Item 3.**Development Application: 810-812A George Street Haymarket**

File No.: D/2019/120

Summary

Figure 29: The rear elevation on St Laurence Lane, with the maximum 50 metre height of building development standard in red

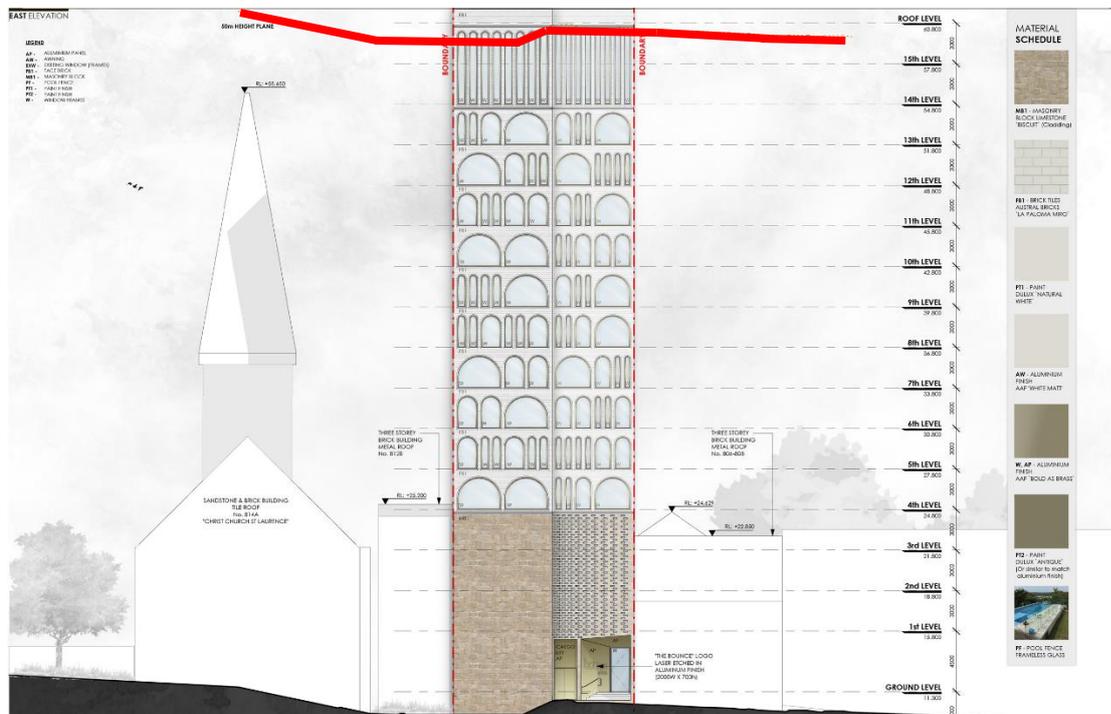
- 52. The site is subject to a maximum building height of 50 metres. The proposed development has a building height of 52.2 metres. The development exceeds the maximum height standard by 4.4%.

59. The assertion that exceeding the height standard provides improved amenity to occupants by locating communal facilities on the uppermost floor is not considered an environmental planning ground sufficient to justify a variation, as these facilities could be located one floor lower and provide the same amenity whilst achieving compliance. It is noted that the development does not provide the minimum recommended provision of communal facilities in accordance with Section 4.4.8.4 of the Sydney DCP 2012. The location of services, plant and lift overrun on the roof would also not be compromised by reducing the height of the building by a storey to comply.
